HEARING STATEMENT

Policy SB24: Sion Hill, Bath Site Allocation – Hearing Statement

- 1.1 Context Planning Ltd have been instructed to prepare this hearing statement on behalf of the Bath Preservation Trust (BPT). This statement responds to the Inspector's initial matters, issues and questions (EXAM 4), in particular Q.33 and Q.34 and should be read in conjunction with BPT's earlier representations.

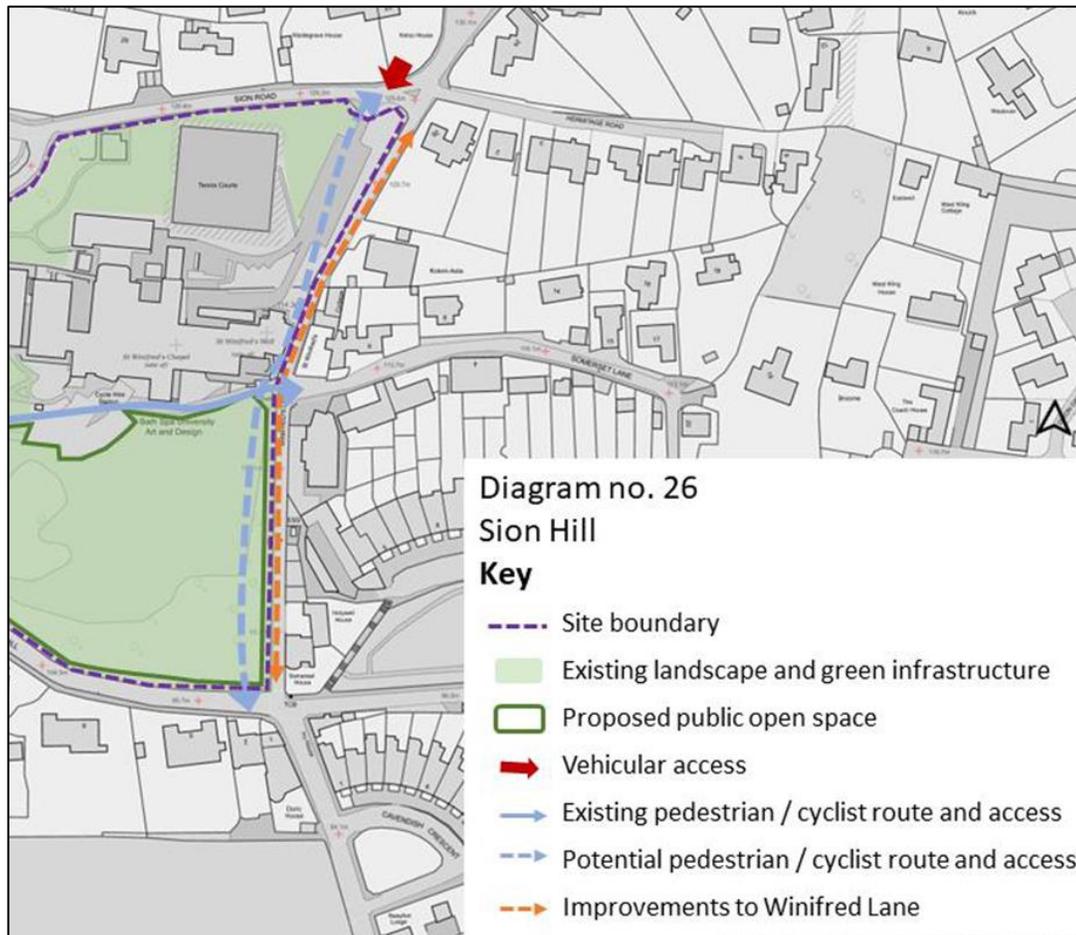
- 1.36** Criteria 9 and 10 of the policy set out a number of measures to enhance the site's walking and cycling opportunities. The supporting concept diagram indicates a potential pedestrian/cycle route through the site along the eastern boundary in parallel to Winifred Lane, which is expected to be linked to the wider walking and cycling network (see below).

- 1.37** The preliminary indication of the route however appears to be problematic in relation to the group of mature trees and planting concentrated at the south-east corner of the site. Placing the pass further into the site to avoid harm to boundary planting would make it less obvious to the walkers/cyclists and less attractive in respect of 'desire lines' as it will require a detour from the direct link along Winifred Lane.

- 1.38** Provision of a segregated route also effectively enables the ongoing use of Winifred Lane as a through route for traffic seeking to shortcut to the top of Lansdown. The requirement for options 'to be investigated' to reduce traffic flows and speeds along Winifred's Lane should be strengthened to reduce the associated risk to highway safety.

1.39 The proposed parallel link, within the site, doesn't appear to be in line with B&NES Strategic Network Bath City Routes document (Sustrans, November 2014) (Appendix C), which suggested investigation of closure of Winifred's Lane at the junction with Somerset Lane or alternatively a contraflow with appropriate signage.
